Name of Proposal: Crystal Lake Golf and Country Club

Review Type: Development of Regional Impact

DEVELOPMENT OF REGIONAL IMPACT

Preliminary Report:	January 10, 2007	DEVELOPMENT OF REGIONAL IMPACT REVIEW REPORT	Project:	Crystal Lake Golf and Country Club
Final Report	February 9, 2007		Comments	January 24, 2007

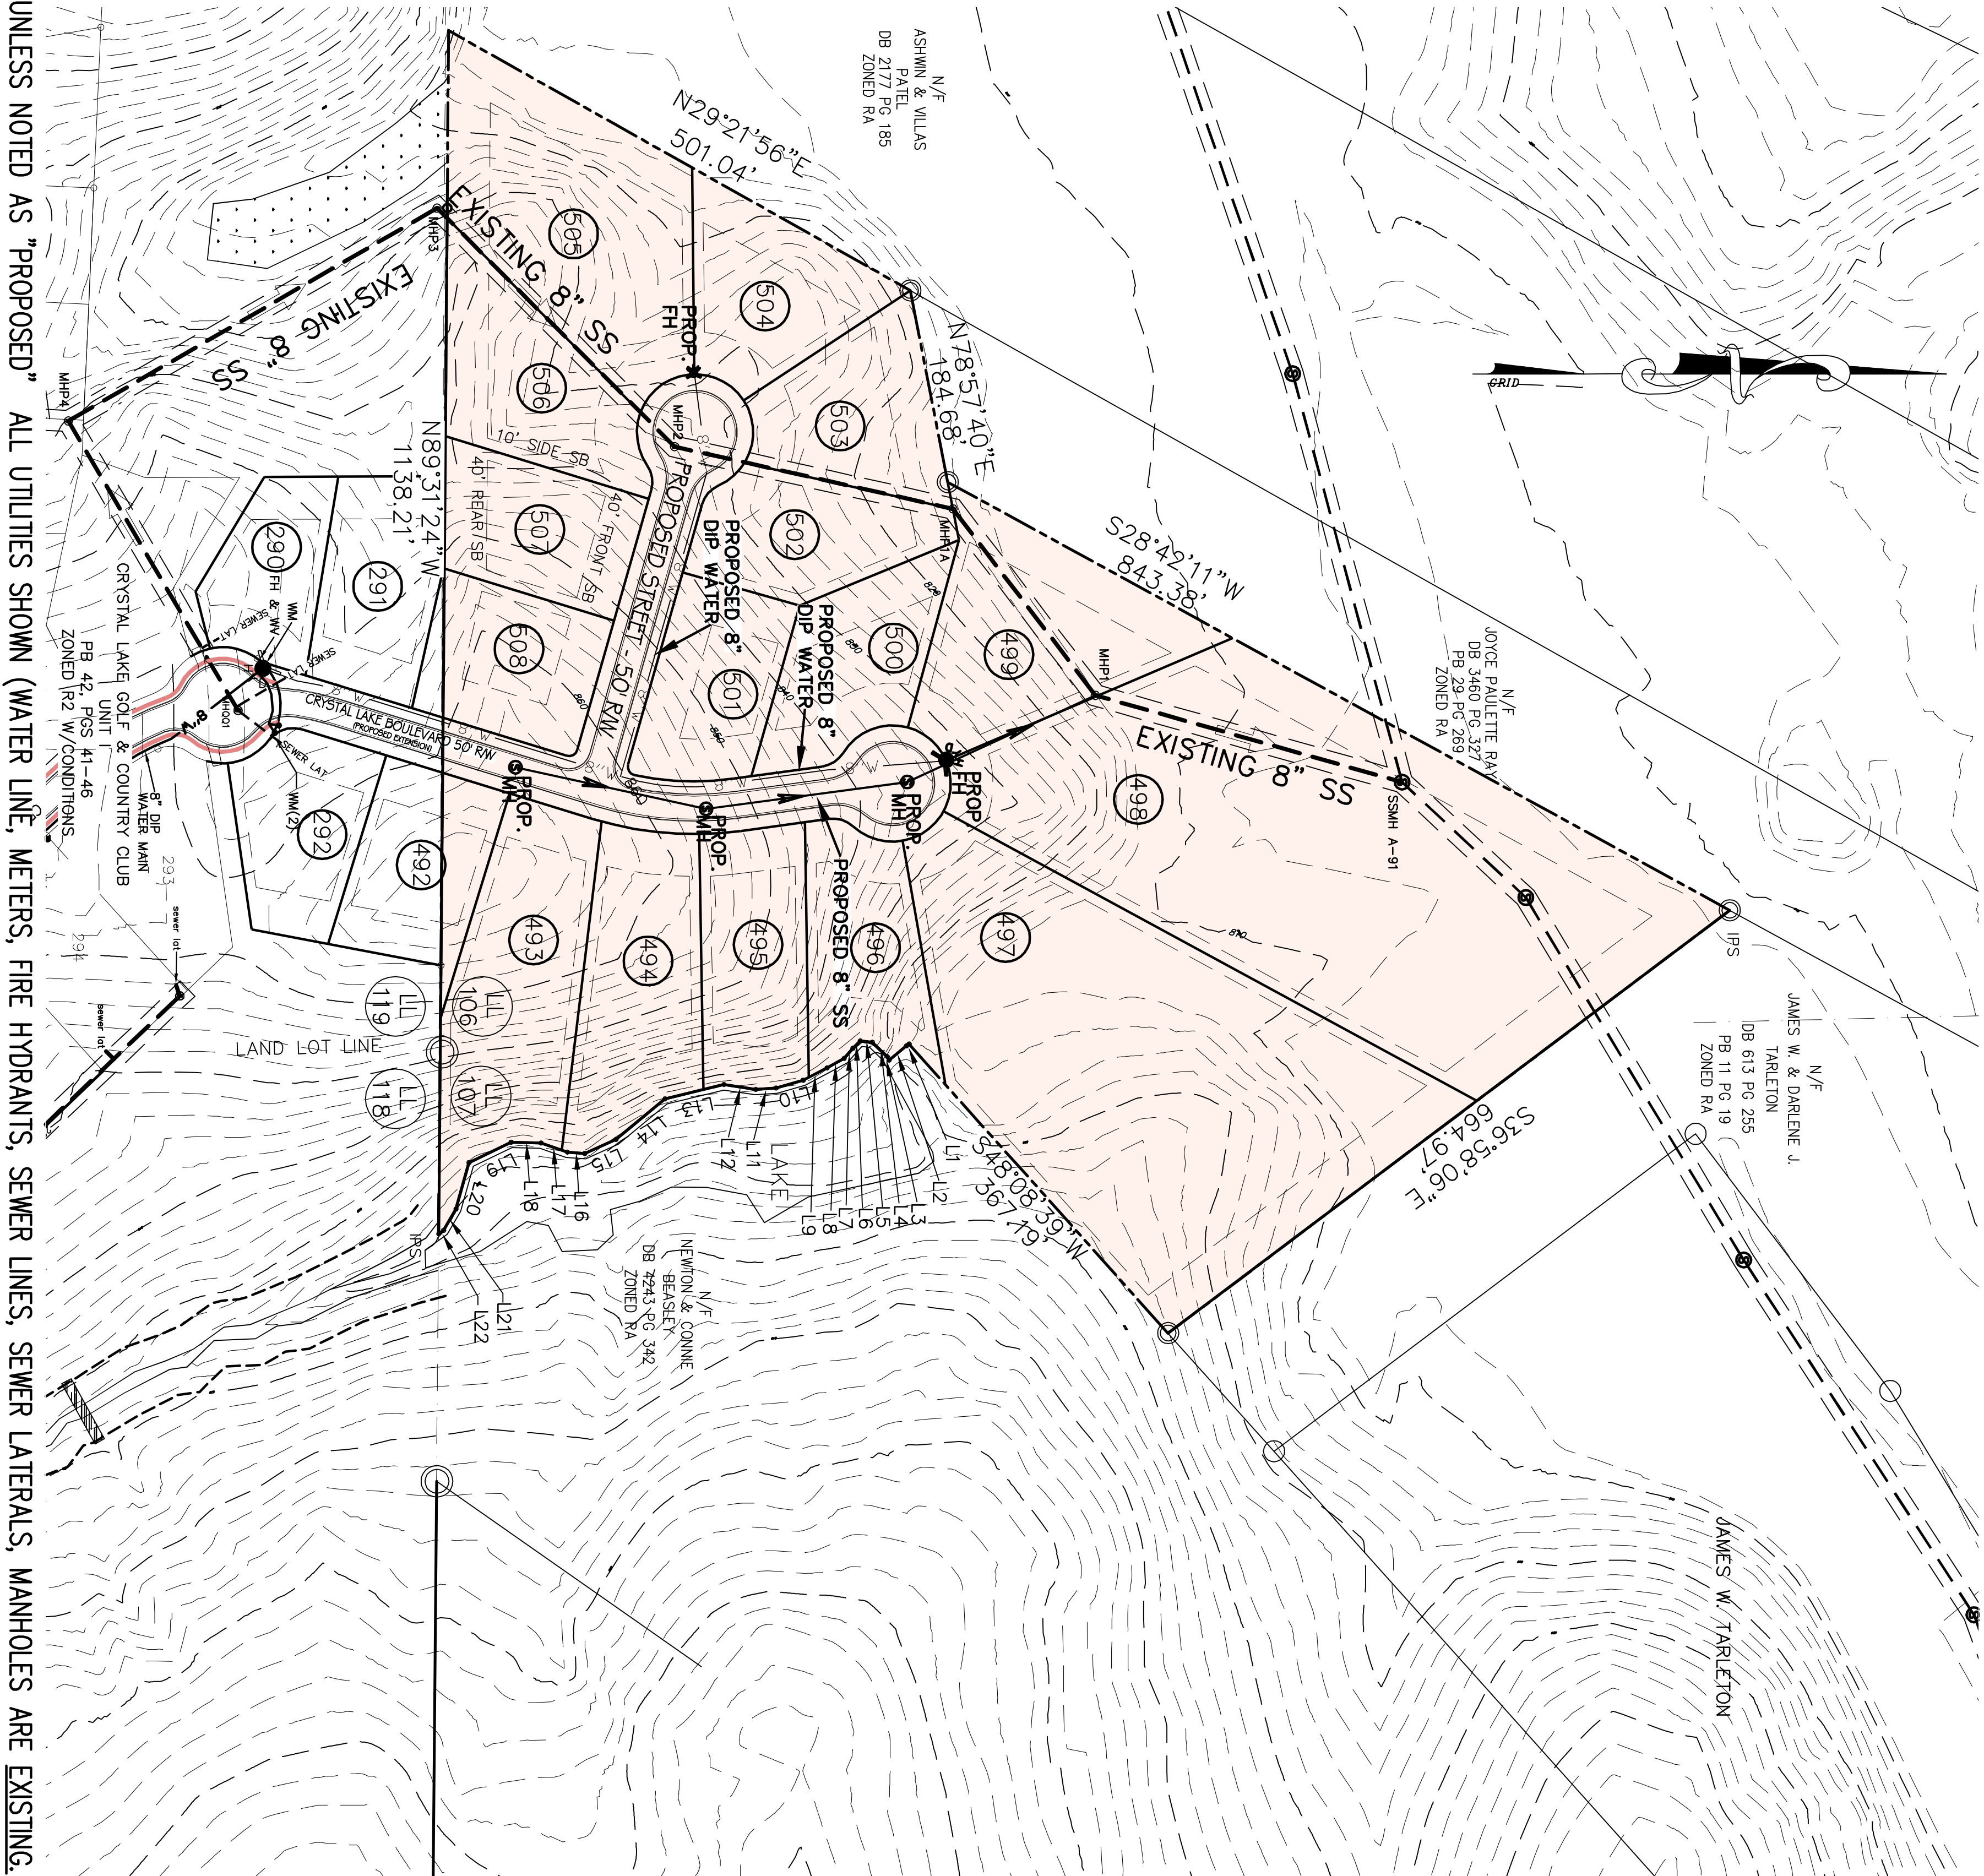
Based on the USGS coverage for the project area, a blue-line tributary to Walnut Creek appears to cut across Lots 497 and 498, but neither the stream nor any buffers are shown. If this or any other stream is on the property, the project must conform to the relevant buffer requirements of the County's Walnut Creek Protection District and must meet the requirements of the County's Stream Buffer Ordinance, which has been adopted as one of the stormwater ordinances required under the Metropolitan North Georgia Water Planning District's District-wide Watershed Management Plan. Any work in the County buffers must meet ordinance requirements or a variance must be approved by the County.

The current site plan does not clearly indicate how stormwater runoff will be managed. In order to address post-construction stormwater runoff quality and quantity, the project should implement stormwater management controls (structural and/or nonstructural) as found in the Georgia Stormwater Management Manual (www.georgiastormwater.com) and meet the stormwater management quantity and quality criteria outlined in the Manual.
